# **LOUISIANA BUILDING DESIGN**

**TECHNICAL REVIEW**  
**JULY 22, 1996**

MID STATION "B" FLOOR PLAN  
 $\frac{1}{8}$ " = 1'-0"  
LA-A-201

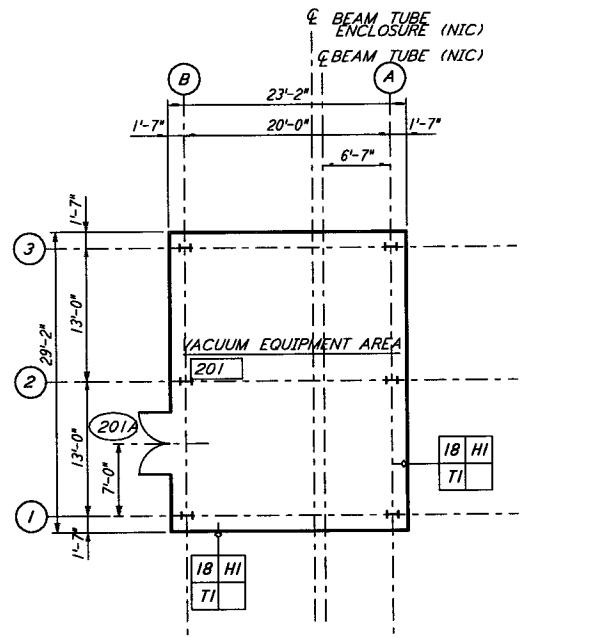
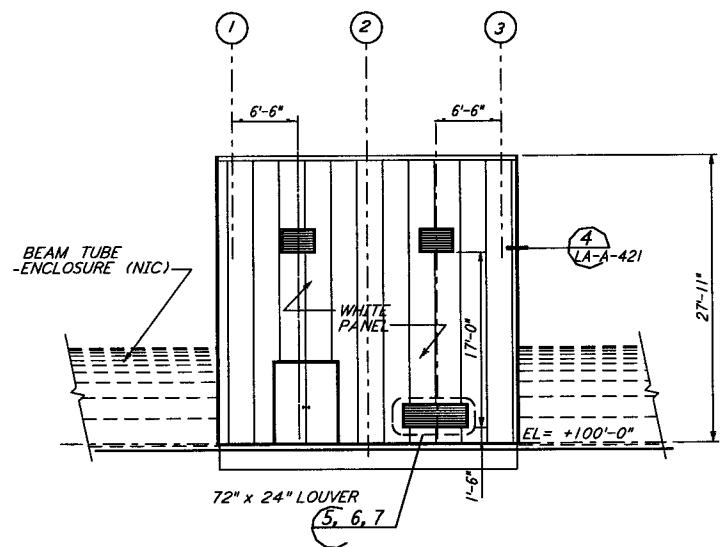
- Weather protection for valve only
  - no power, no water, no HVAC
  - Conduit stub-ups, same as 250 m points
  - internal roof height of 23 feet to accommodate gate valve disassembly
  - floor space of 20 x26 feet for clear area around valve
  - 6 x 8 foot roll up door for gate valve installation
  - Louvers provide ventilation
  - Entire foundation acts as the termination slab
- Operational considerations
  - Power is only required during acceptance testing and bake; this can be installed on a temporary basis
  - Valve operation during operation is minimal and can be accomplished either manually or with portable generator

# Rain-Roof-Wall-Drainage

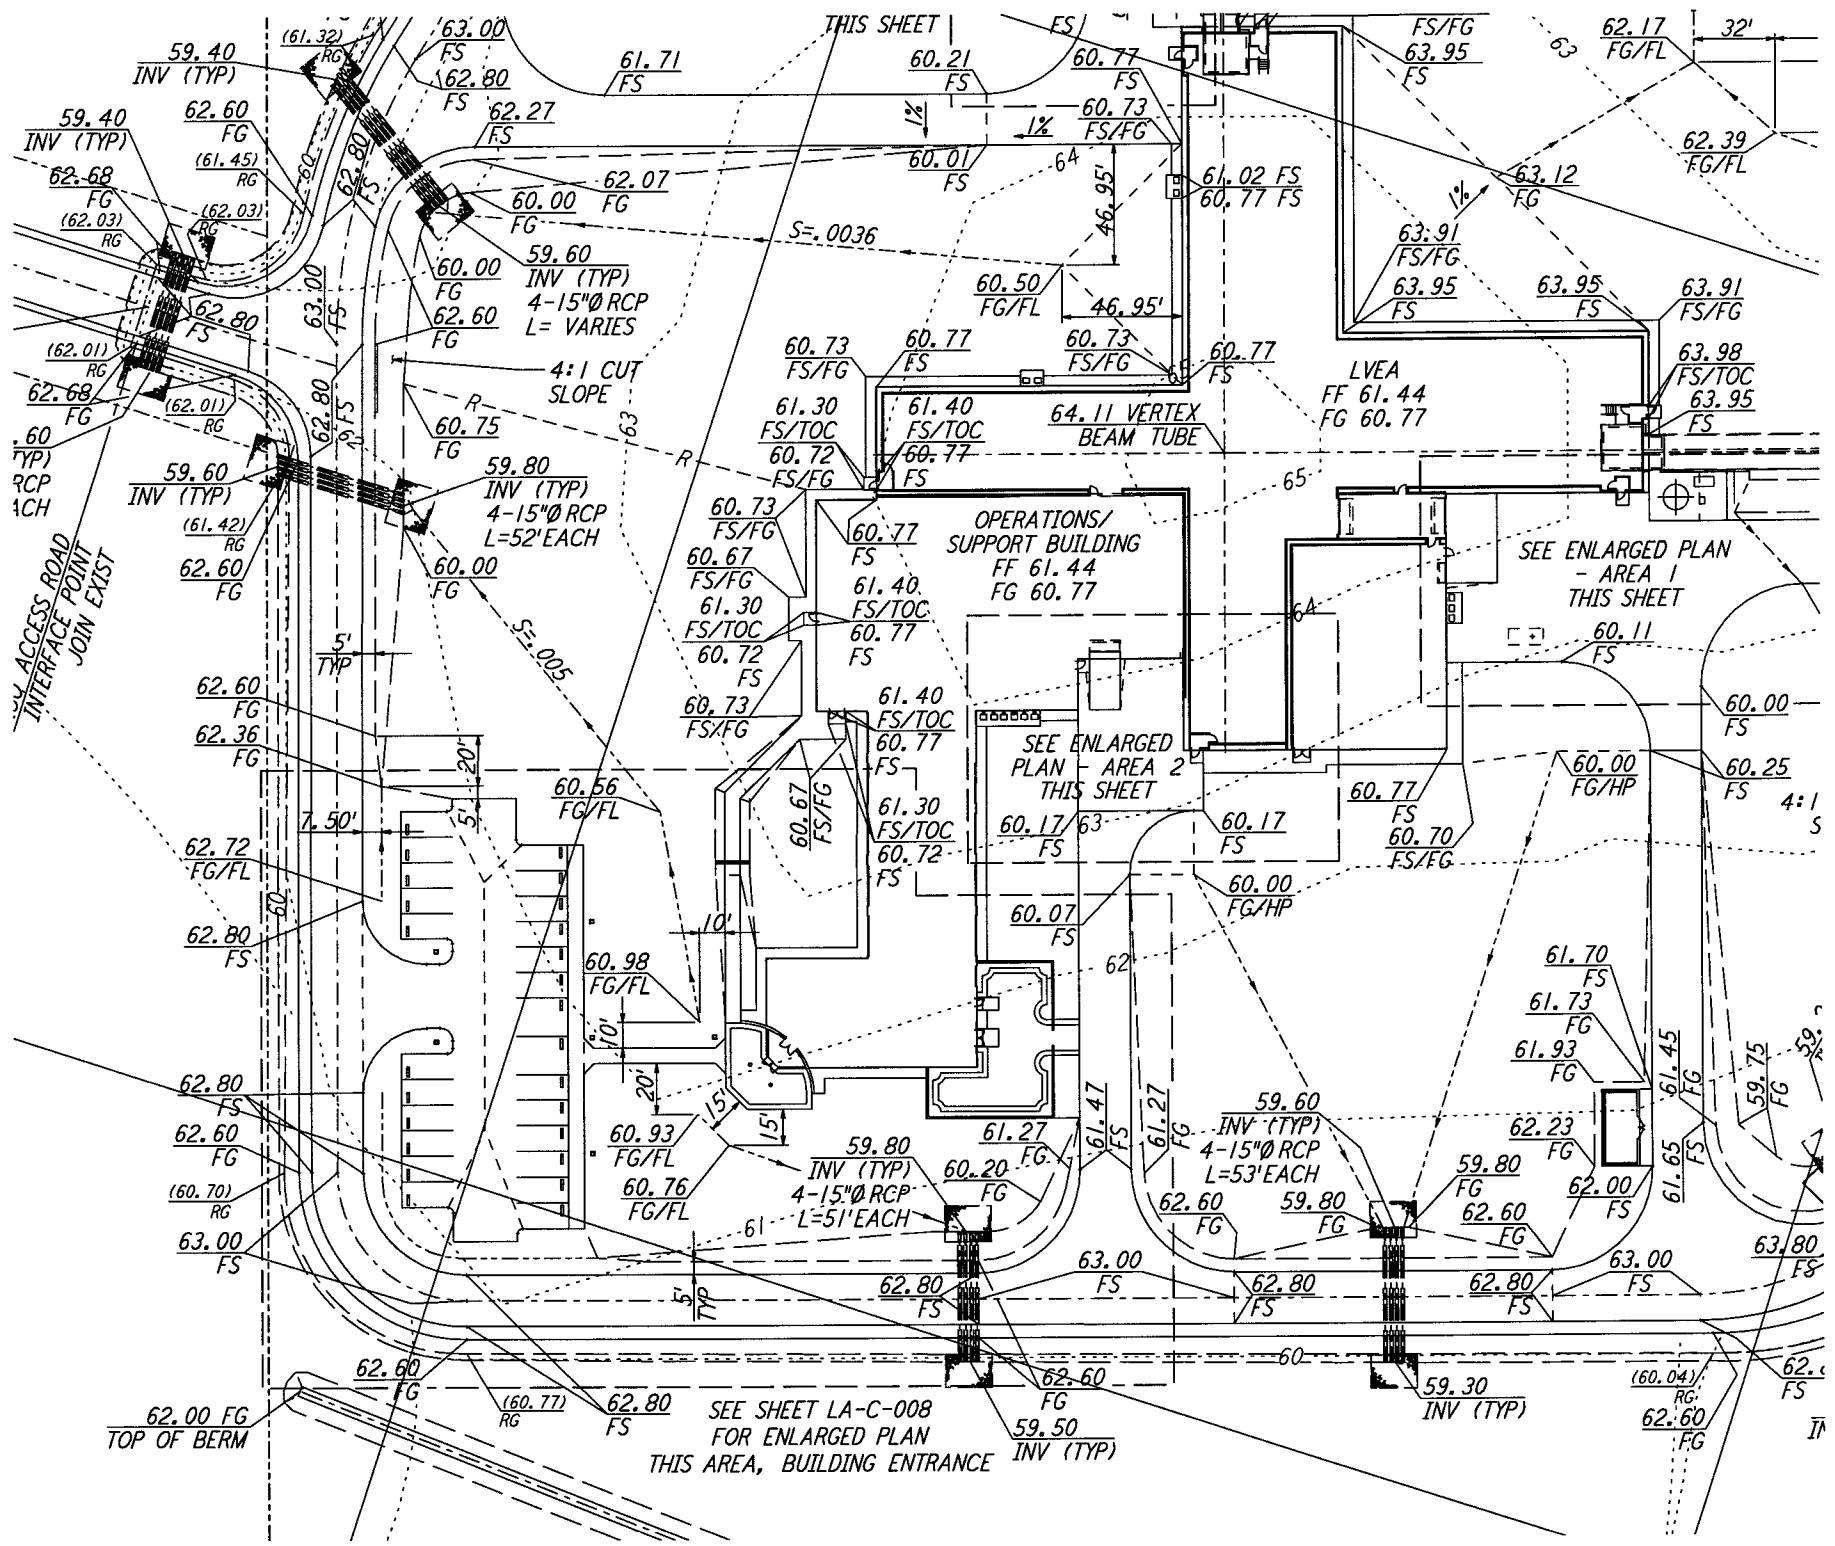
- Concern over water influx at eves, through wall and on top of foundation
  - Specifications for wall panels, caulking provisions, mud sill and eve details were reviewed by Desmond his recommendations incorporated by Parsons
- Drainage provisions
  - 30 " retaining wall at "back" side of LVEA
  - Corner station area drains away from buildings using culverts under service roads
  - All building floors are above 500 year flood level
